BAR Meeting
May 6, 2009

ISSUE: Alterations and Signage

LOCATION: 134 North Royal Street (Gadsby's Tavern)

BAR CASE #2008-0235

Glass Exhibit Panels – Tradesman’s Entrance

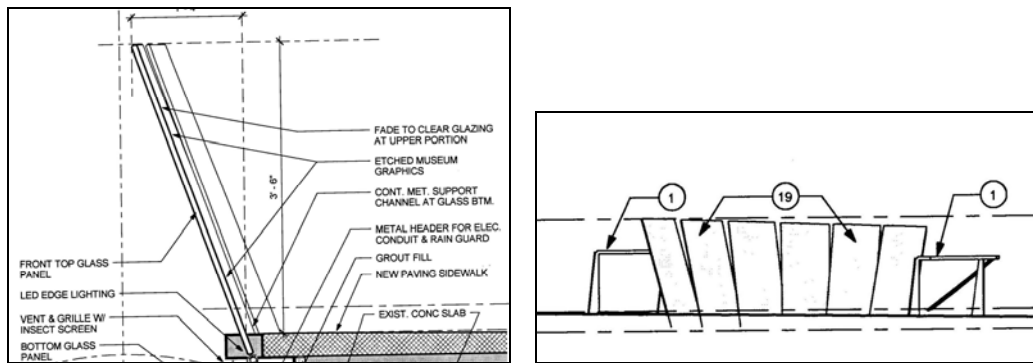
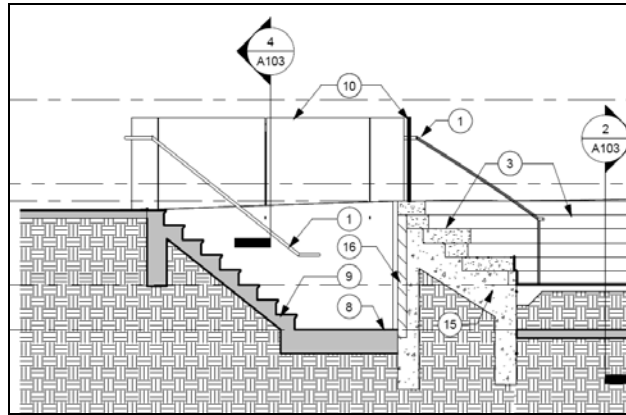
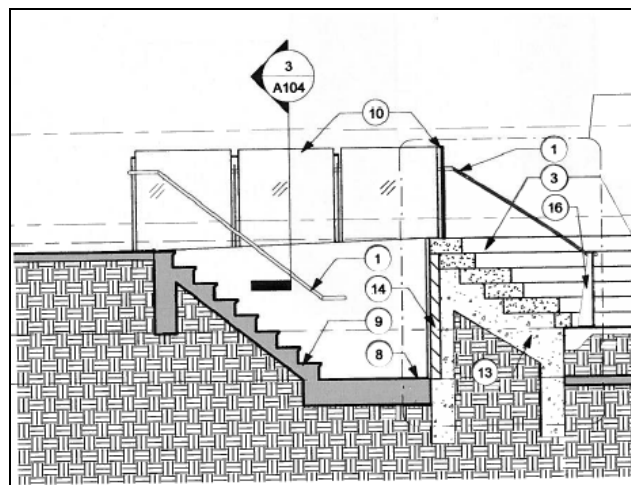
Original Design (December 2008):

The existing metal guard rails were to be replaced with an internally lit, solid plate glass exhibit panel fabricated in a frosted safety glass.

Current Design:

The existing metal guard rails are being replaced with three, separate, externally lit, glass exhibit panels fabricated in a slightly frosted glass. The support detail for these panels is for its form to replicate an ice tool.

Lighting

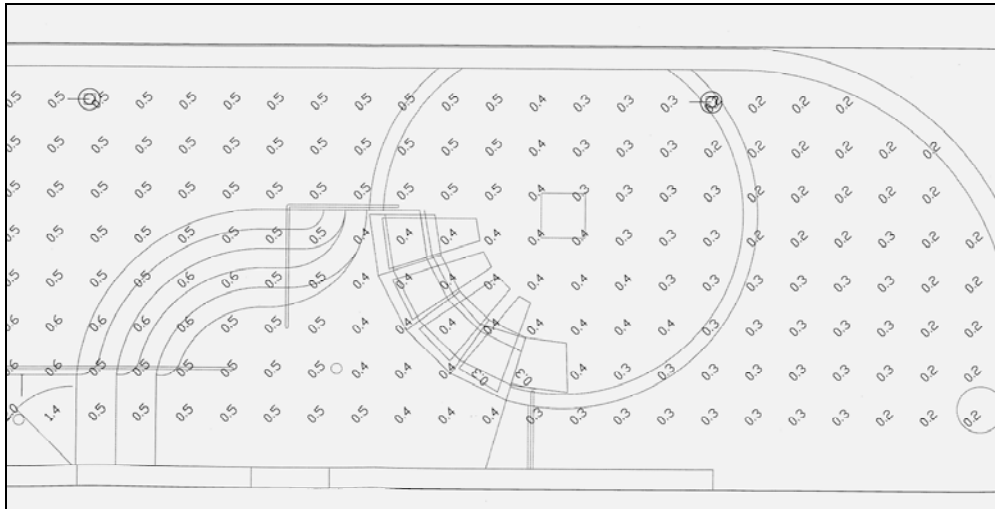
The original lighting design provided a significant amount of light spillage beyond the ice well into the surrounding public Right-of-Way (ROW). It was the recommendation of Staff to reduce the lighting levels to mitigate the projects impact on pedestrians, drivers and the adjacent community. It was recommended that the Applicant attempt to achieve illumination levels of 0.6 footcandles or below in the public ROW.

The revised lighting design has changed dramatically from the original submittal. The glass panels will be lit utilizing low level LED lights. The new photometric plan illustrates that the lighting levels

will not exceed the Staff recommended 0.5 footcandles at curb edge. A substantial reduction from the original design which had illumination levels reaching 1.1 footcandles at curb edge and well over 10 footcandles over the ice well opening.

Figure 12: Archaeology Limits of Disturbance

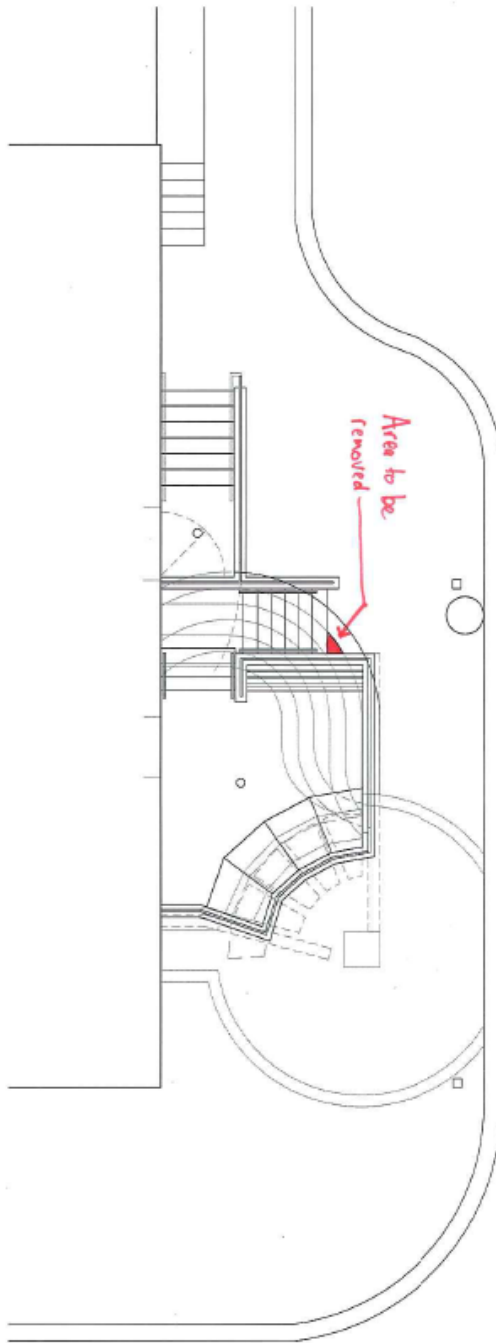
The proposed design will have very minimal impacts to undisturbed earth. The applicant has provided a drawing indicating the Limits of New Disturbance for the project (see Figure 12). The shaded area in the drawing indicates where the Applicant proposes to cut into earth that has not already been previously impacted. As shown, these areas are very minimal, and will be monitored by City Archaeology staff.

The new design will have very minimal impacts to undisturbed earth. The applicant only proposes to excavate a very small area which has not been previously impacted. The remaining project will be undertaken on the existing site's footprint. As shown in the recommended conditions, the City Archaeology Staff proposes to monitor all phases of the project to ensure the project maintains conformance to the strict Limits of Disturbance (LOD) and footprint.
